NOTICE OF REVISION (NOR)		1. DATE (YYMMDD) 98-06-12	Form Approved OMB No. 0704-0188
THIS REVISION DESCRIBED BELOW HAS BEEN AUTHORIZED FOR THE DOCUMENT LISTED.			
Public reporting burden for this collection is estimated to average 2 hours per response, including the time for reviewing instructions, searching existing data sources, gathering and maintaining the data needed, and completing and reviewing the collection of information. Send comments regarding this burden estimate or any other aspect of this collection of information, including suggestions for reducing this burden, to Department of Defense, Washington Headquarters Services, Directorate for Information Operations and Reports, 1215 Jefferson Davis Highway, Suite 1204, Arlington, VA 22202-4302, and to the Office of Management and Budget, Paperwork Reduction Project (0704-0188), Washington, DC 20503. PLEASE DO NOT RETURN YOUR COMPLETED FORM TO EITHER OF THESE ADDRESSES. RETURN COMPLETED FORM TO THE GOVERNMENT ISSUING CONTRACTING OFFICER FOR THE CONTRACT/ PROCURING ACTIVITY NUMBER LISTED IN ITEM 2 OF THIS FORM.		2. PROCURING ACTIVITY NO.

3. DODAAC	
4. ORIGINATOR	b. ADDRESS (<i>Street, City, State, Zip Code</i>) Defense Suppl

FIGURE A-1

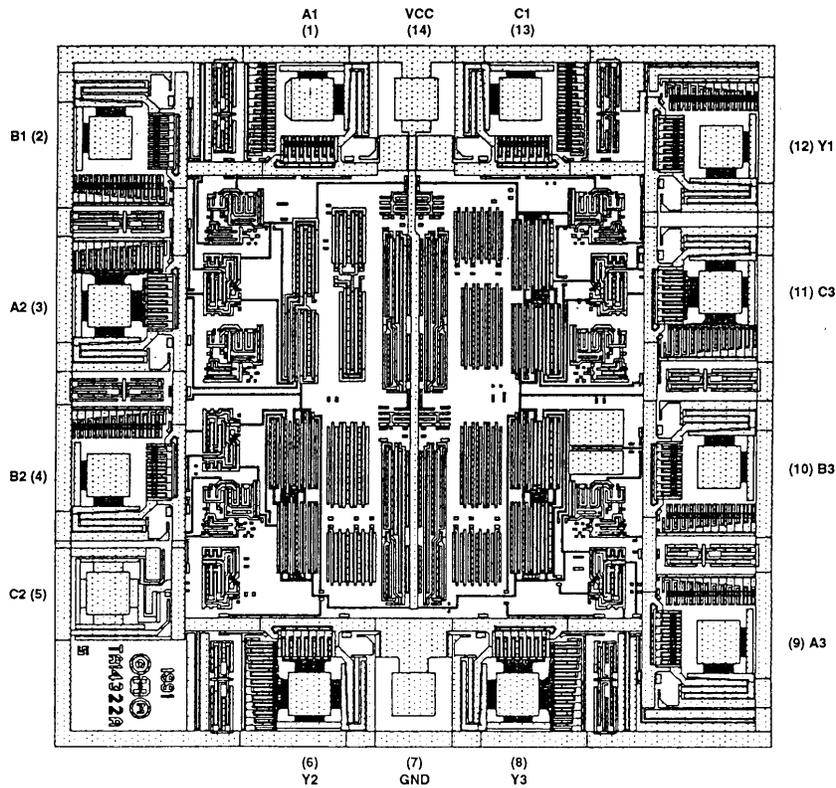
a. CURRENT -	b. NEW A
11. ECP NO. No users listed.			
12. CONFIGURATION ITEM (OR SYSTEM) TO WHICH ECP APPLIES All			
13. DESCRIPTION OF REVISION Sheet 1: Revisions ltr column; add "A". Revisions description column; add "Changes in accordance with NOR 5962-R123-98". Revisions date column; add "98-06-12". Revision level block; add "A". Rev status of sheets; for sheets 1, 4, and 16 through 22, add "A". Sheet 4: Add new paragraph which states; "3.1.1 <u>Microcircuit die</u> . For the requirements for microcircuit die, see appendix A to this document." Revision level block; add "A". Sheets 16 through 22: Add attached appendix A. CONTINUED ON NEXT SHEETS

o DIE PHYSICAL DIMENSIONS

Die Size: 2200 x 2240 microns.
 Die Thickness: 21 +/- 2 mils.

The following metallization diagram supplies the locations and electrical functions of the bonding pads. The internal metallization layout and alphanumeric information contained within this diagram may or may not represent the actual circuit defined by this SMD.

o INTERFACE MATERIALS

Top Metallization: SiAl 11.0kA +/- 1kA

Type: SiO2
Thickness 13.0kA +/- 2.6kA

Substrate: Silicon on Sapphire (SOS)

Substrate Potential: Insulator

Special assembly instructions: Bond pad #14 (VCC) first.
